Change Notice

Epoxy Seal at Base of Terminals

Epoxy Seal

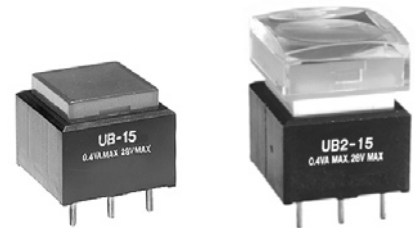
The epoxy seal material at the base of the UB and UB2 Series terminals is changing. The new light blue epoxy seal will replace the current green epoxy, and improve the strength of the terminals at the base.

Before Change

Green
Epoxy Seal

After Change

Light Blue
Epoxy Seal

Note: There is no change to the dimensions of the switches.
